# CBM-Caledon Quarry

## CAART COMMENT SUMMARY TABLE RESPONSE #1 – [VISUAL IMPACT]

Initial CAART Comments (March 2025)	Page / Section	Applicant Response (Oct. 30, 2025)	CAART Response (April 23 2026)	Applicant Response (May 28, 2026)	CAART Response (June 4, 2026)	Applicant Response
<b>Report: Comments on the Visual Impact Assessment prepared by Golder + Landscape Plans by MHBC</b>			<b>Author: J. Fedorowick, Wavefront Planning and Design Incorporated</b>			
<b>Methodology and Accuracy</b>

Location of parking lots from which the northern quarry is visible.

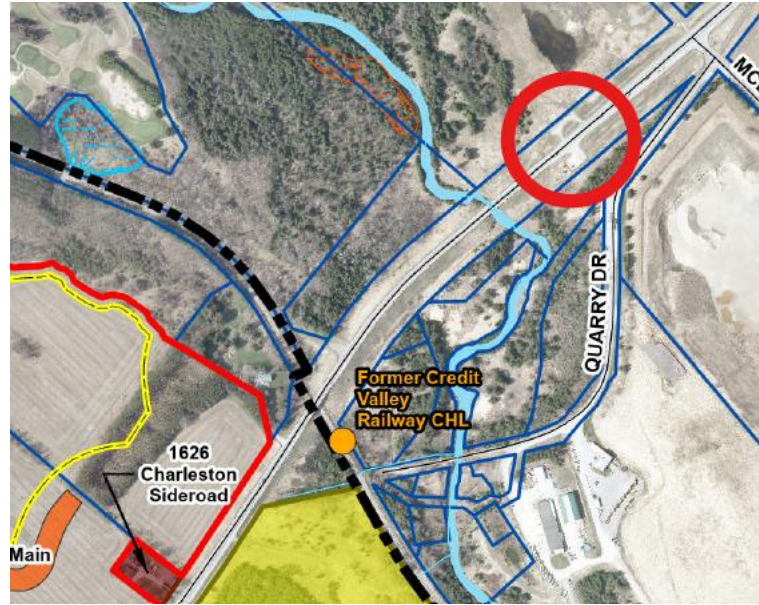
3.	Two viewpoints that offer panoramic and direct views of the extraction area were identified in the field but are not included in the VIA report.	VIA Peer Review Item 5.1, pg. 16	Viewpoints at public parking lots located on both sides of Charleston, northeast of the Credit River will not have a view of the Project. Adding an additional viewpoint at the south boundary of the North Extraction Area on Charleston Sideroad will not change the overall weak contrast rating for the effects assessment.	See attached location at the end of this document ... if you go out to the parking lots shown within the red circle, you can see the hedgerows in the Northern section. What type of mitigation would you propose for this panoramic view?	Upon careful review of the view from the noted parking lots (see image below), there is no need for a simulation from these locations as there is an extensive mature woodland between the parking lots and the quarry and the small cluster of trees that is to be removed within the Phase 2B limit of extraction is currently not visible from the parking lots.
